# Advanced Technology Centre, Vale of Glamorgan

## Transport Assessment Addendum

### WEPco Limited

CAVC Advanced Technology Centre, Vale of Glamorgan	CAVC		
<b>PROPOSED SITE ACCESS GENERAL ARRANGEMENT VISIBILITY SPLAYS &amp; SWEPT PATH ANALYSIS</b>			
DRAWN: RJ	CHECKED: KR	DATE: 12.12.23	SCALES: 1:500 at A3
DRAWING NUMBER: 237449_PD02	REVISION: B

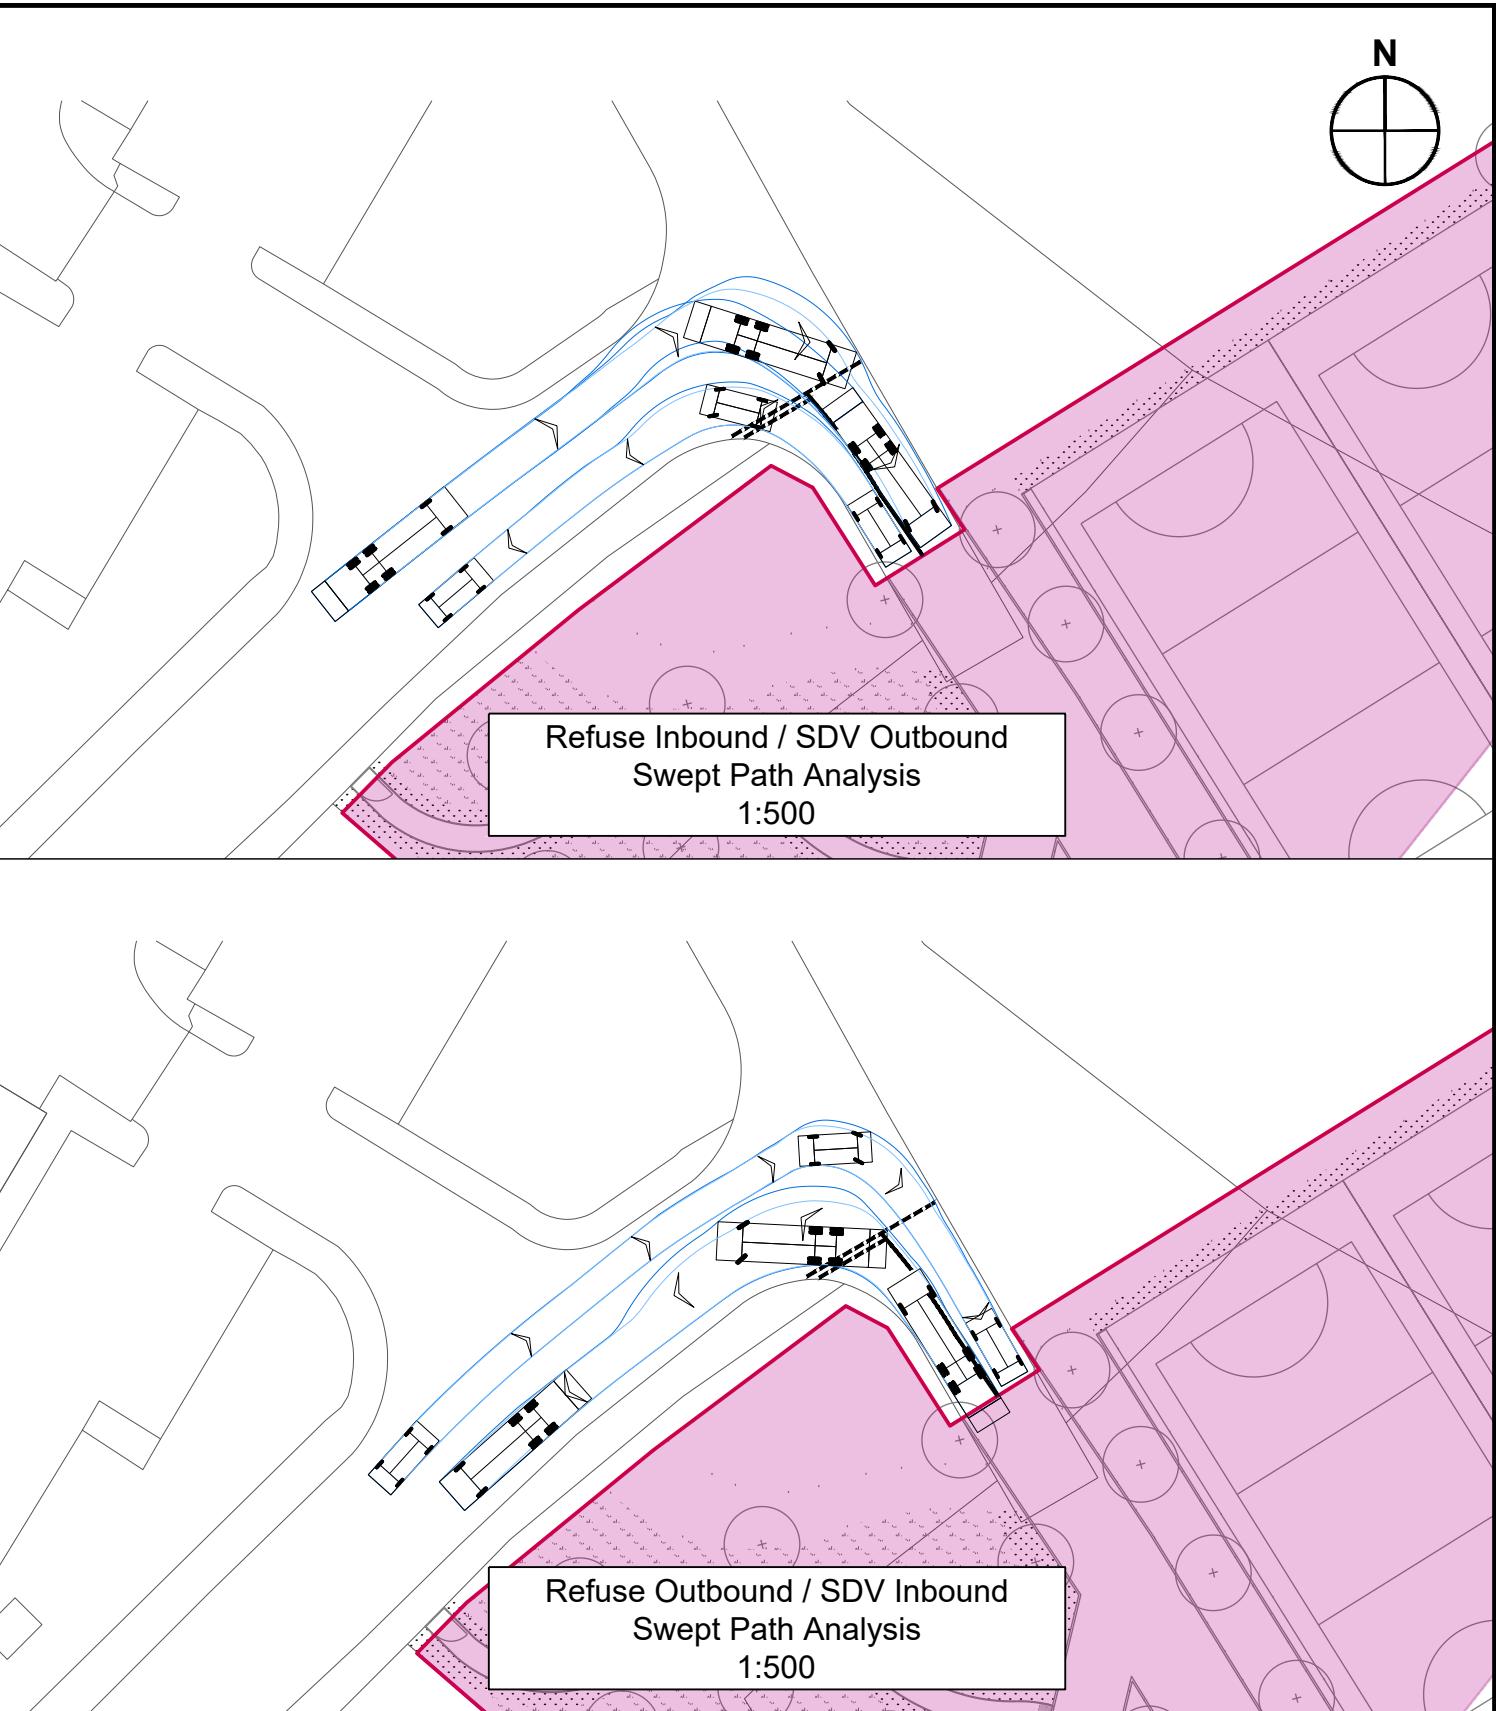
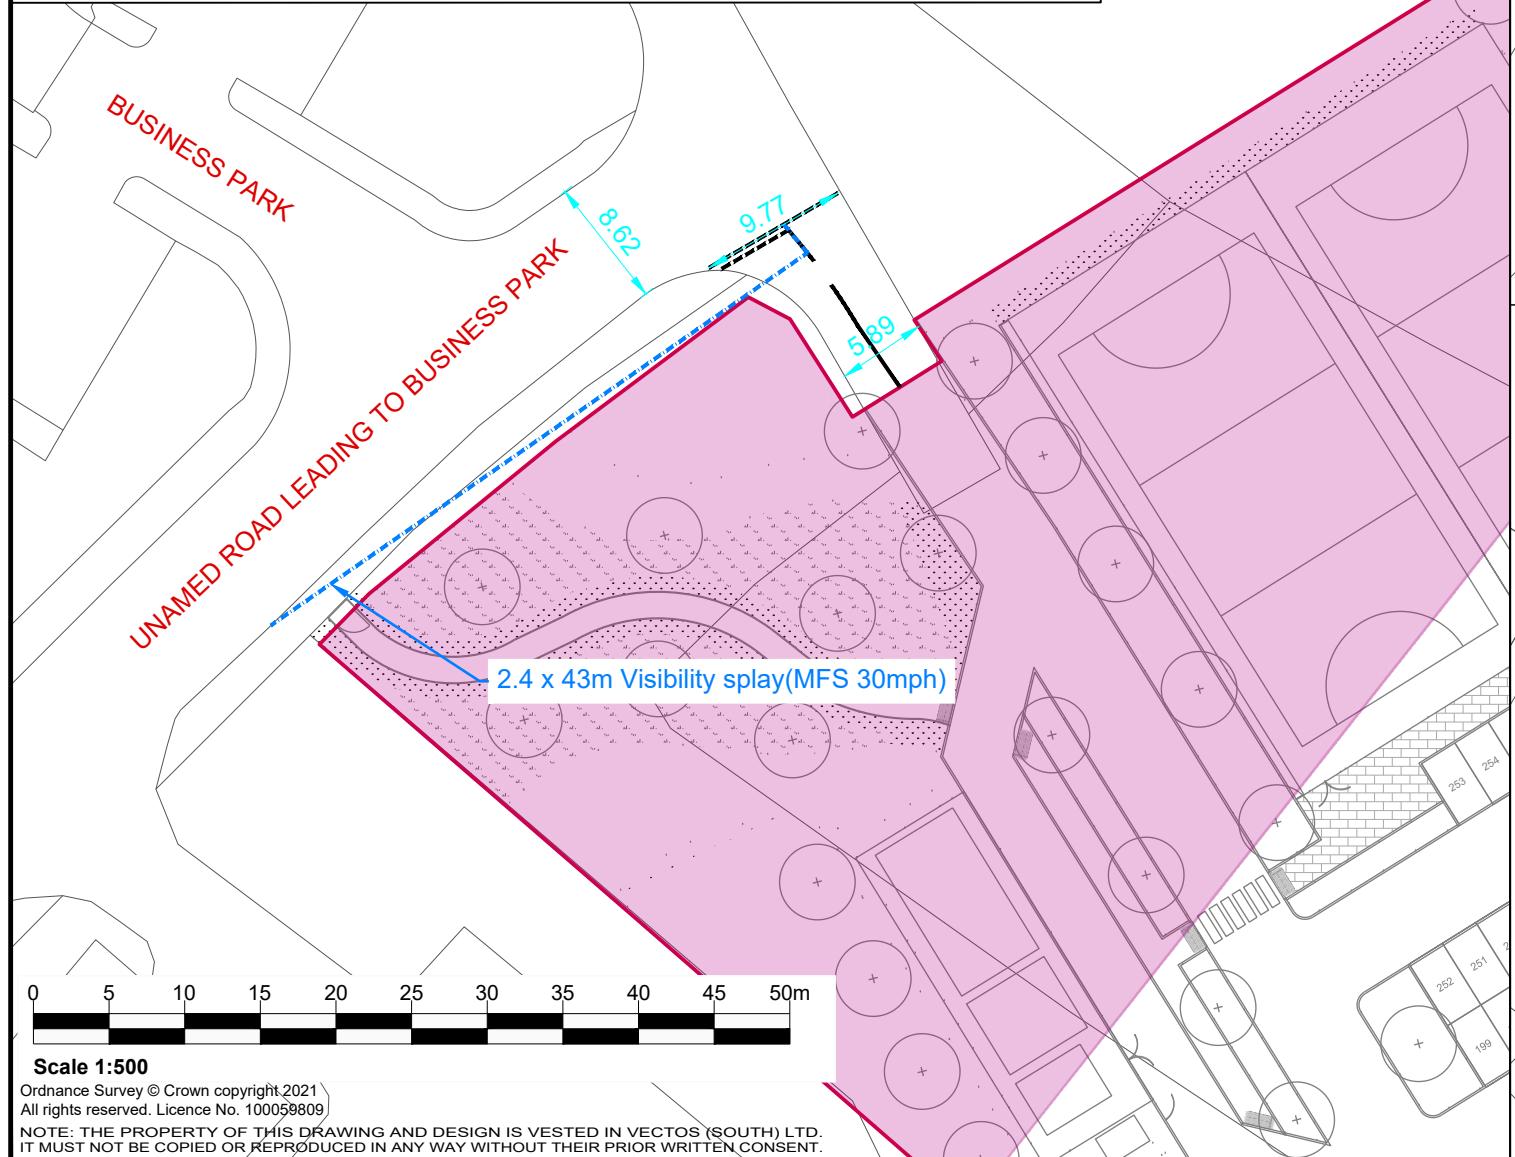
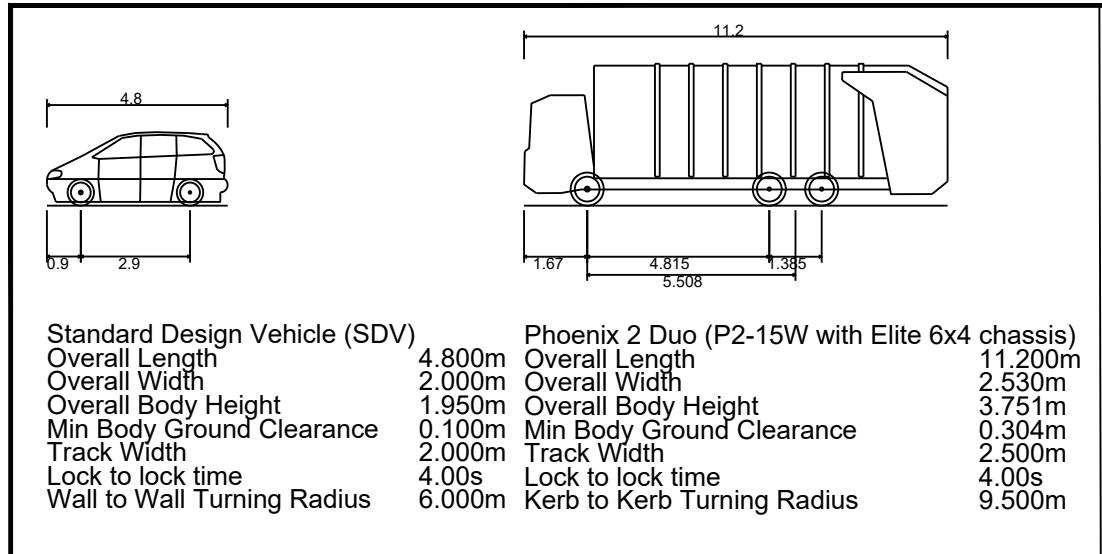
2.13 Provide proposals of where service/delivery vehicles will drop off goods and ensure that reversing on site in close proximity to other members of the public/parking spaces is prevented. Swept paths should also be provided.

2.16 Any access road specified to be used by HGV's should be 7.3m wide. A access road and parking GA should be provided showing widths/geometry.

- 3.27 Additional swept path analysis is to be provided, to include HGVs. VoGC to confirm the required refuse collection vehicle size.

2.17 The width of the access road is 5.9m wide and, as stated in the TA, the existing road width is appropriate for the types and frequencies of vehicles accessing the site.

2.18 A general arrangement drawing of the site access junction has been included at Appendix G of the submitted TA, along with the swept path analysis. The swept path analysis has been updated to include an 11.2m refuse vehicle (shown in **Appendix B**), and concludes that the existing road width is sufficient to accommodate the types of vehicles accessing/egressing the site.

- 3.28 Additional swept path analysis has been undertaken based on a 11.2m refuse vehicle. The swept path analysis demonstrates that the 11.2m refuse vehicle can be accommodated at the site access. This is provided at **Appendix B**.
- 3.29 CAVC has confirmed that the 11.2m refuse vehicle will be the largest vehicle to service the site.
